# Manufacturer Product Service Bulletin

## Number CW03-01

**Subject:** Capewell Supplied Pins and Ripcords

Broken Ripcord Pin

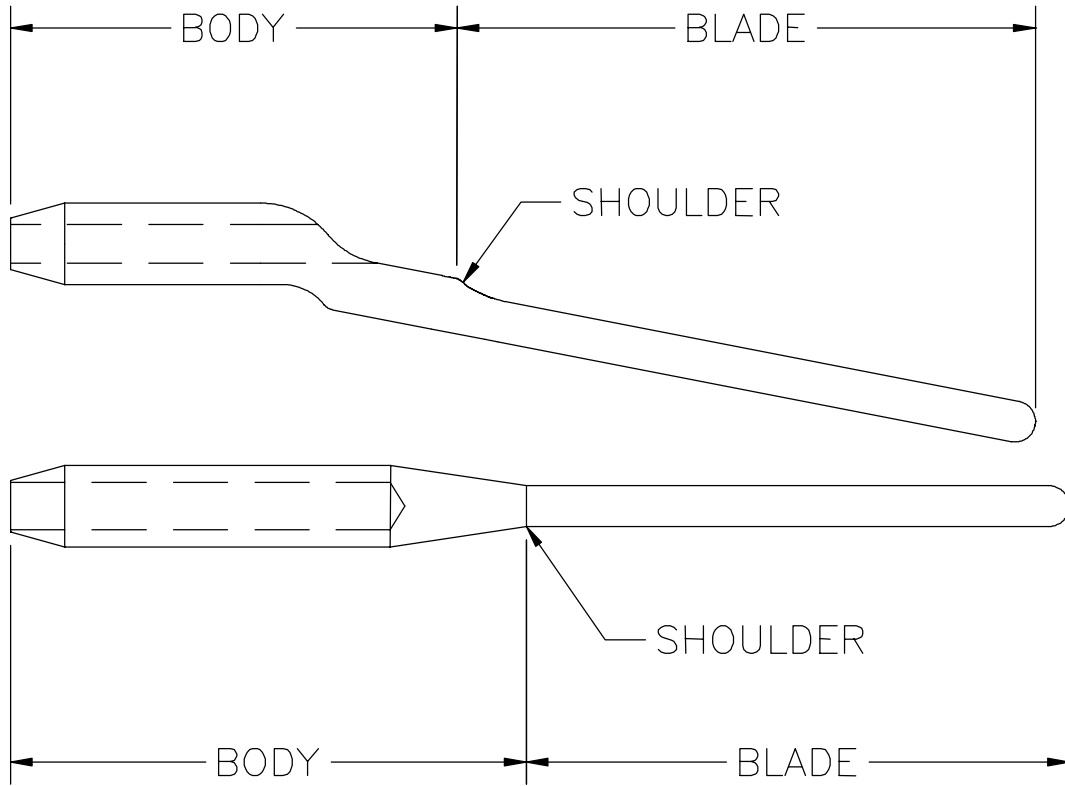
Capewell Components LLC has received (3) reports from (3) customers of (4) ripcord pins that broke. All (4) pins were reported to have broken under very low force. All (4) pins are reported to have broken on the blade section of the pin, approximately 1/8" (3 mm) from the shoulder of the pin. A broken pin is pictured below.

Affected Ripcord Pins are: MS70107 (angled), PS70107 (angled), 61C4304 (angled); 55A6480 (terminal)

**WARNING: A DEFECTIVE PIN COULD CAUSE A PARACHUTE SYSTEM TO MALFUNCTION**

**FIGURE 1**

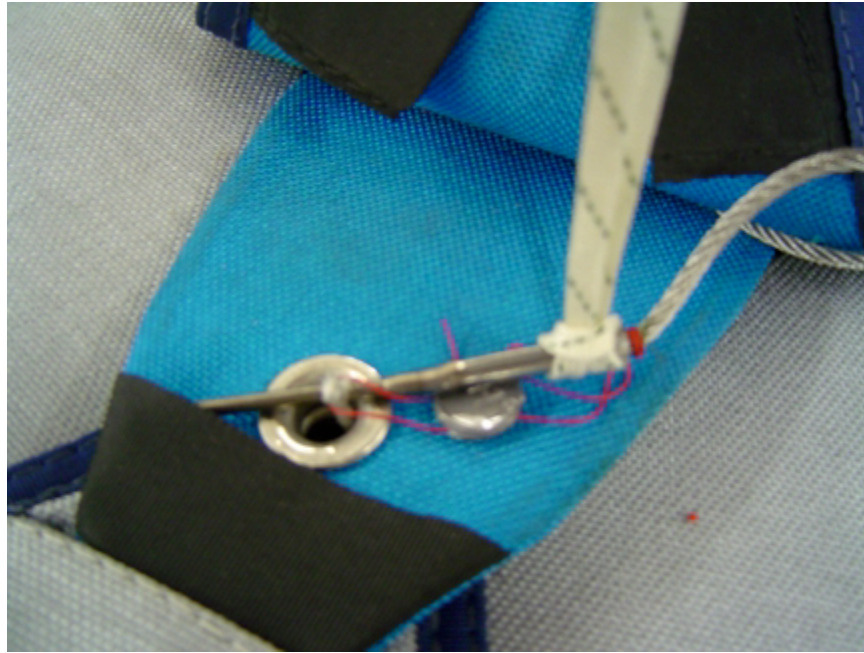
3. Take the suspension line and tie the two ends together with an overhand knot forming a loop.
4. Route the loop around the body of the pin to form a lark's head knot as close to the cable entrance end of the pin body as possible (Fig. 1).

5. Secure the other end of the loop to the spring scale.
6. Apply a load of 15 lbs. (6.8kg) straight up and 90 degrees to the axis of the pin for a period of 3 seconds and then release the load (Fig. 2). Inspect the pin for any deformation or bend. If the pin is straight, continue with step 7 below. If the pin is not straight, as visible without magnification, remove the pin/ripcord from service immediately.

**FIGURE 3**  
All dimension in inches

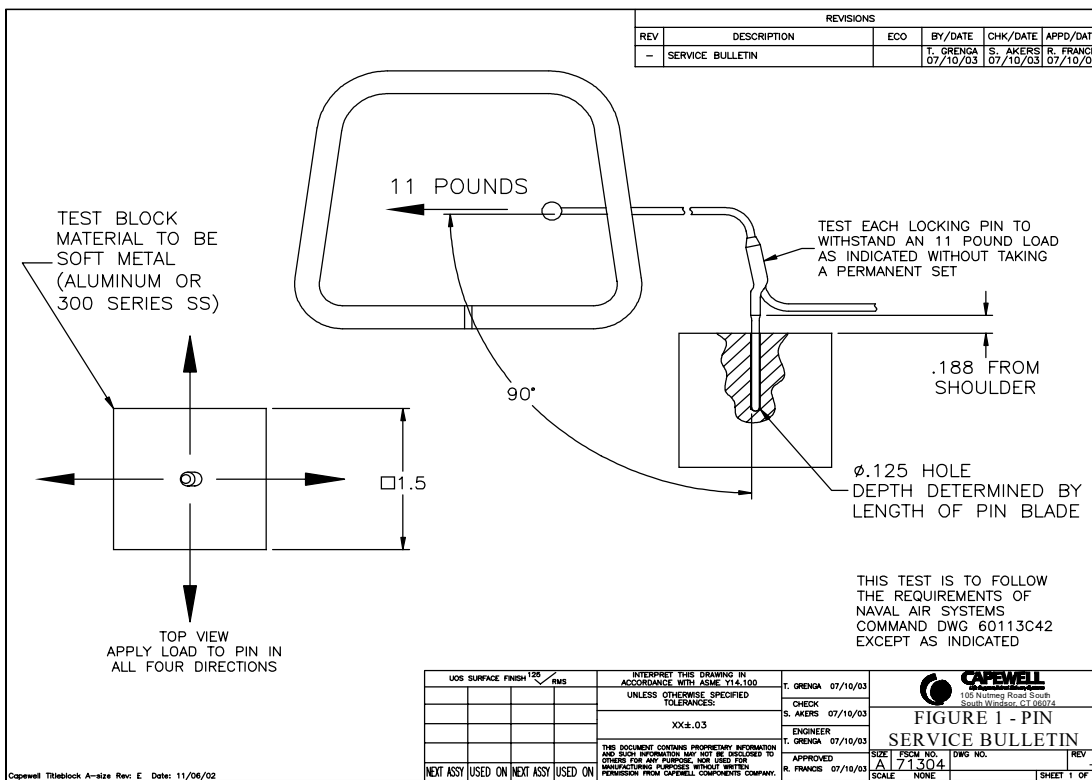
1. Place pin in test block per Figure 3 (below). NOTE: The pin block hole may be VERTICAL or HORIZONTAL
2. Apply 11 lb. force 90 degrees perpendicular to the pin blade.

3. Remove pin from block and inspect:
  - For straightness: Pins in excess of .005 (.12 mm) deformation along the blade of the pin should be removed from service.

- For surface anomalies using 10x magnification. If any surface anomalies (dents, cracks, chips) exist, the pin should be removed from service.
4. Mark the inspected side of the pin with the felt marker to avoid repeatedly testing the same side of the pin
